# **Keystone Sanitary Landfill Phase III**

**MAJOR PERMIT MODIFICATION**

## **Application Review**

**for  
THROOP BOROUGH  
DUNMORE BOROUGH**

FIGURE 4 - Fill Thickness over Liner Grades

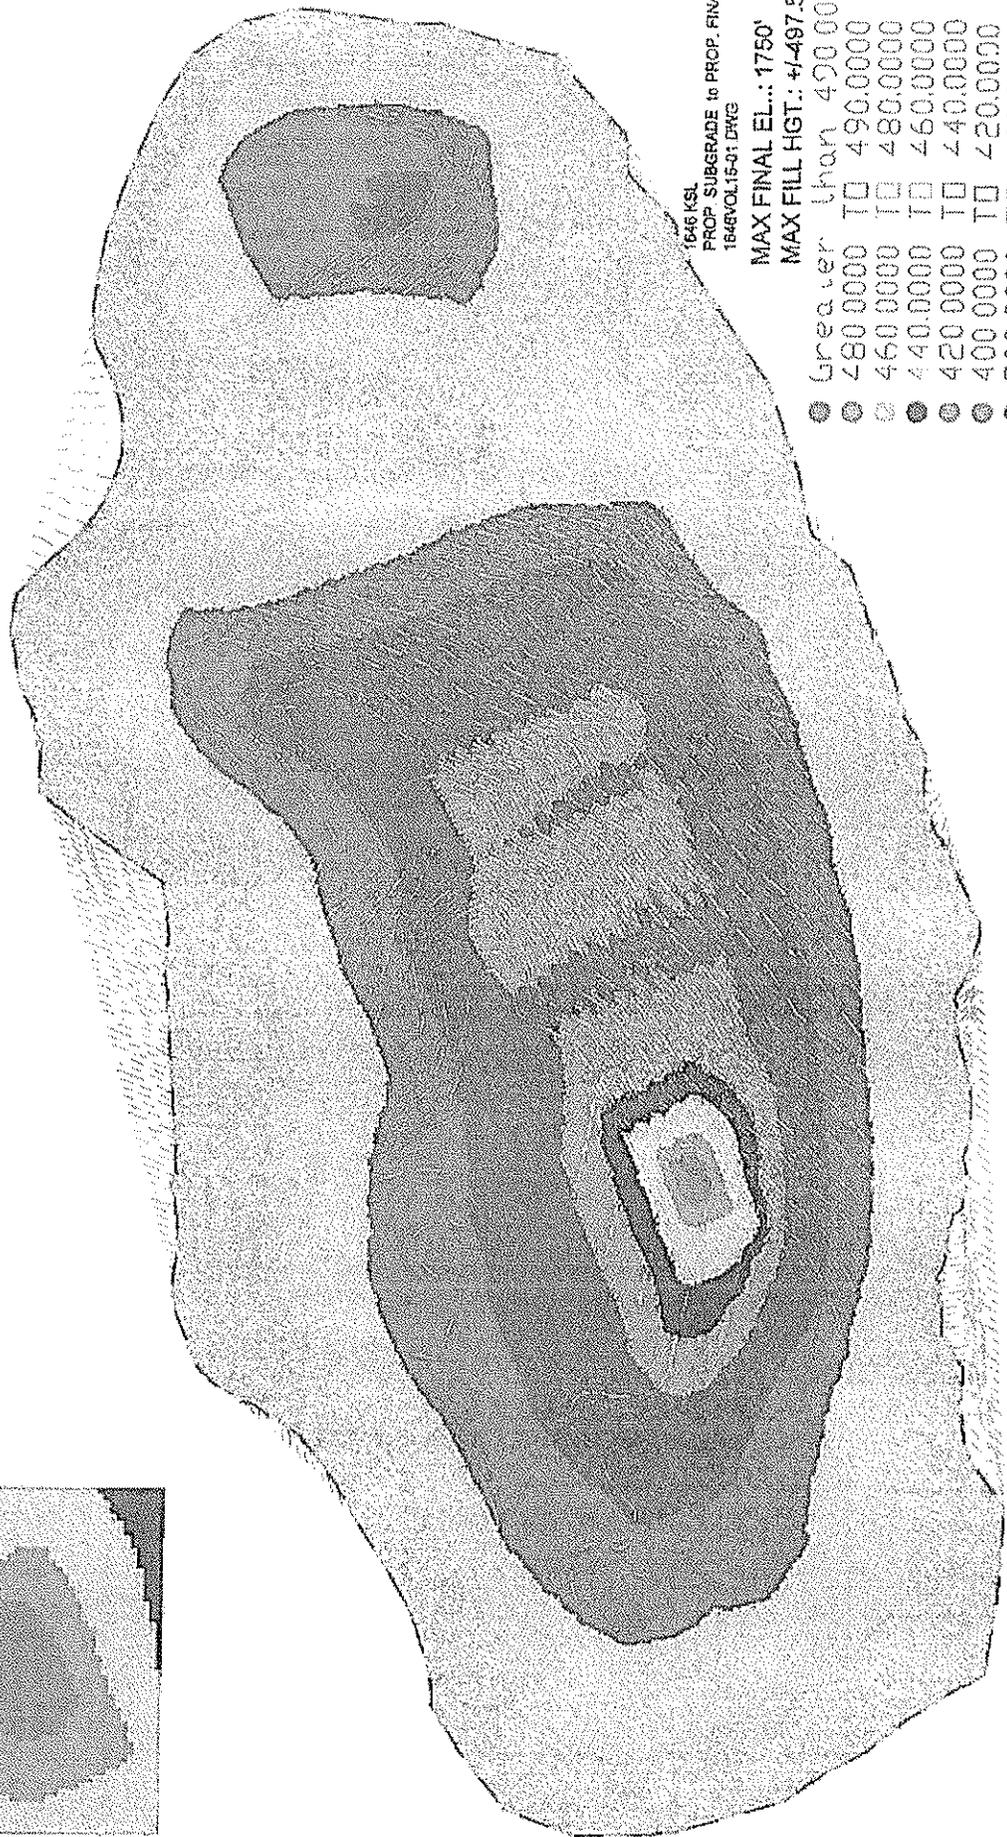
With respect to the depths of waste proposed over the liner grades, Figure 4 shows the range of waste depths by isopach increments, with the red, orange and flesh colored areas being the thickest. The maximum thickness of waste approximates 500 feet. The additional thickness of waste (over either the unfilled areas or the permitted final grades in the four waste footprints) is shown on Figure 5. The maximum additional thickness of
